LPC 307/306 to LPC 308
Upgrading procedure

RCSL No: 44RT-1754

This paper describes the upgrading procedure
for LPC 306/307/308.

LPC 307 to 308 Upgrading.

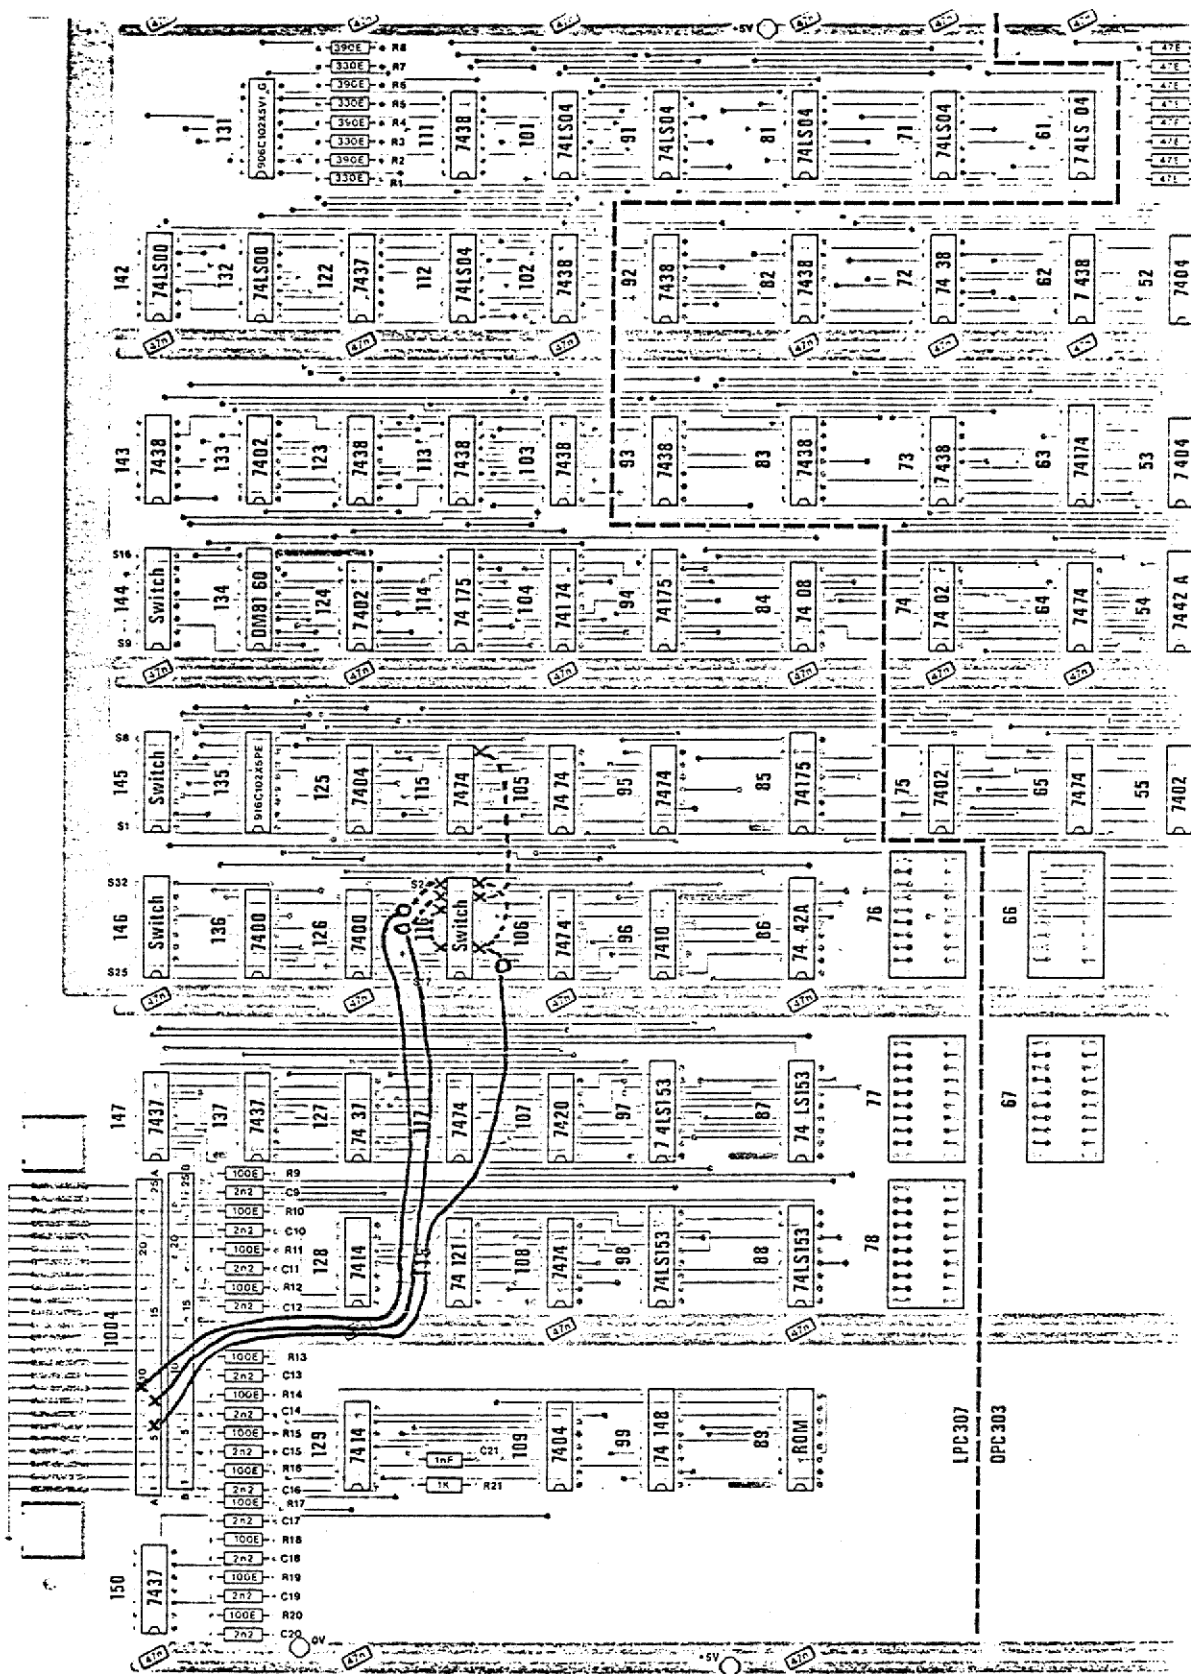
Connect the following:

1. 1004A6 - 116-3 - 116-8
2. 116-11 - 116-14
3. 0V - 116-7
4. 1004A8 - 116-10
5. 1004A9 - 116-9

Set switches:

S19 closed for LPT 726, 727, 728.

S24 closed for LPT 726, 727, 728.
